Cedar Shore Estates 589 King Street West, Cobourg

SWM Design Report

Revised December 2017

DRAFT PLAN OF SUBDIVISION DRT COMMENTS

SUB TITLE: **POST-DEVELOPMENT MAJOR DRAINAGE PLAN**

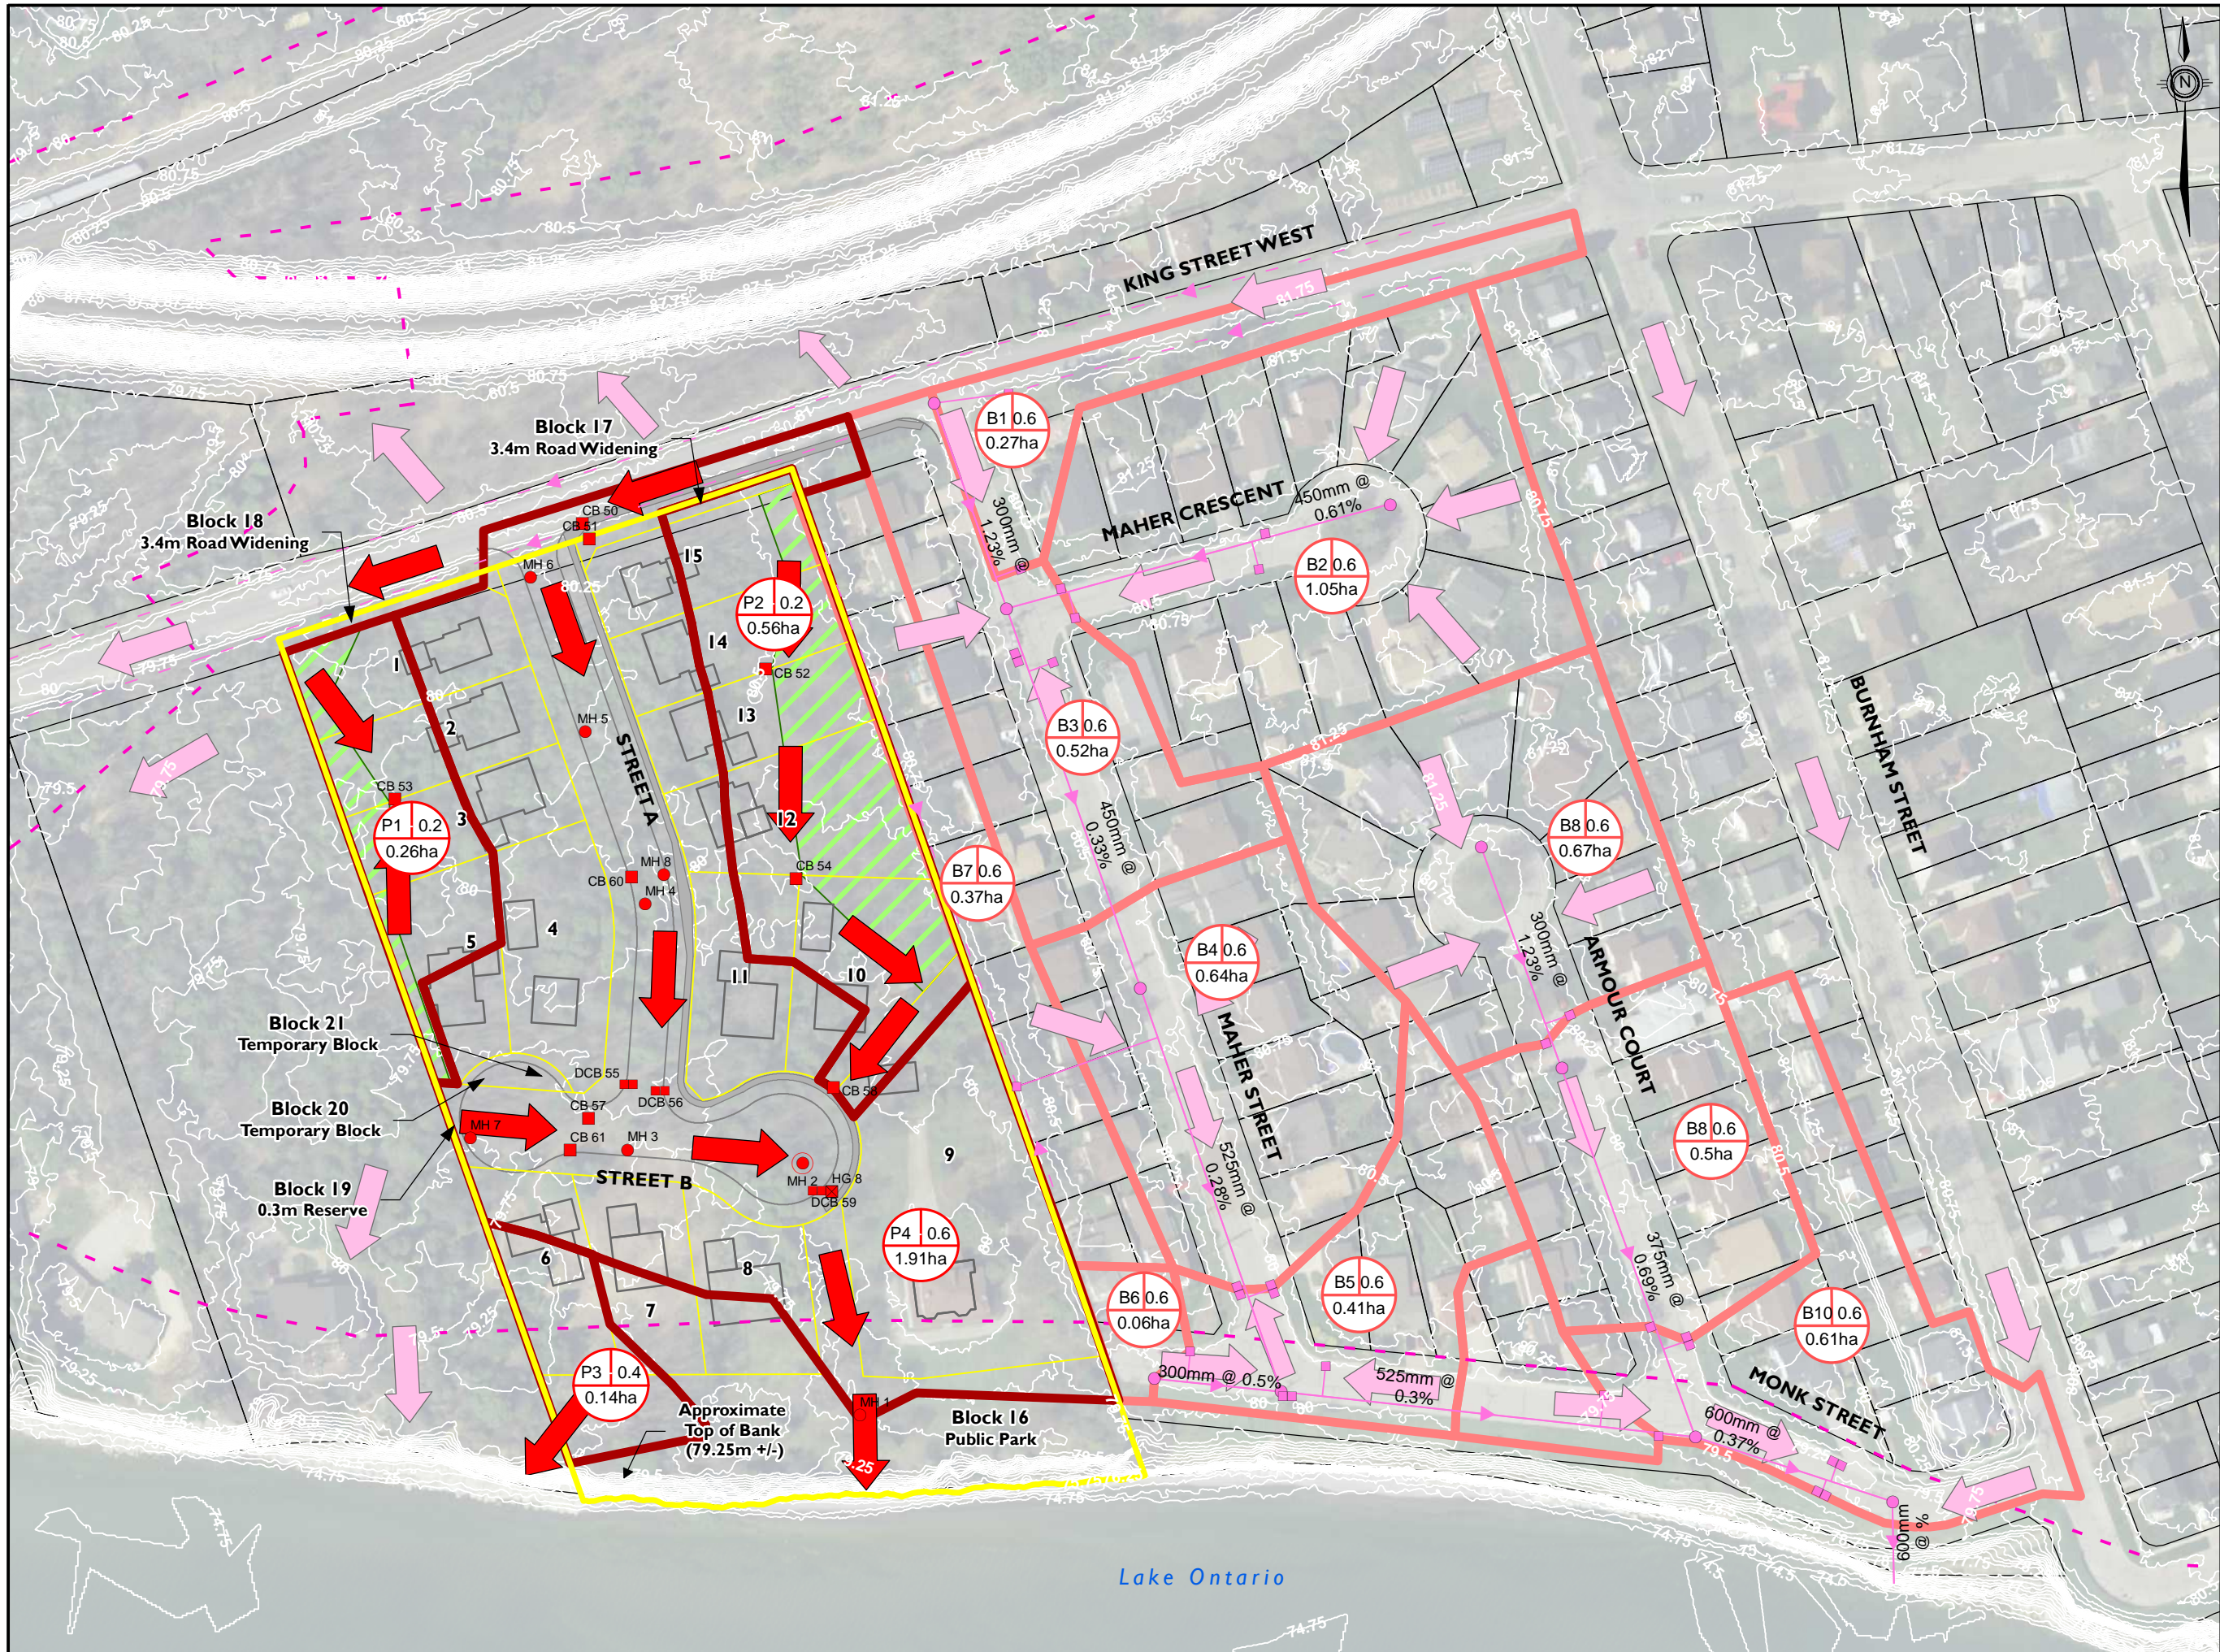
5. In addition to the items listed in bullet #5, the post-development drainage area plan should include: a. Underlying draft plan layout (with lot, block, easement, and road pattern) b. The major flow route c. Conceptual minor system layout d. All SWM facilities	Refer to Appendix C for details.

GRADING PLAN

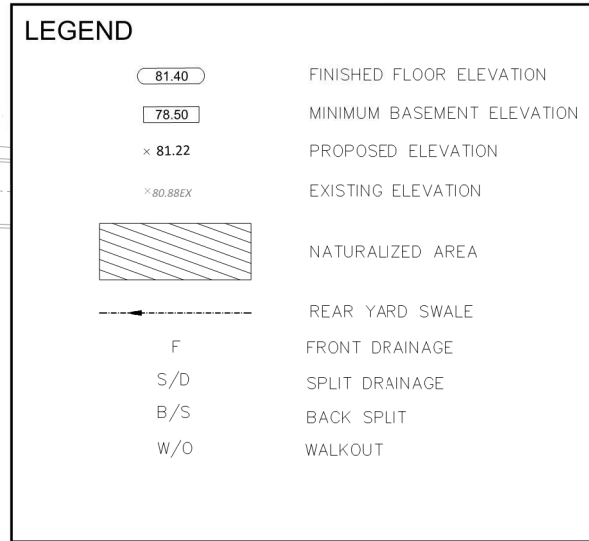
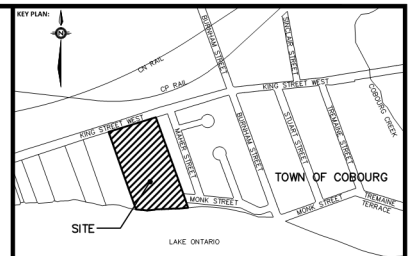
8. A rough grading plan is required to show the proposed grades at key locations, to support the proposed major flow route(s).	Refer to Appendix D for details.
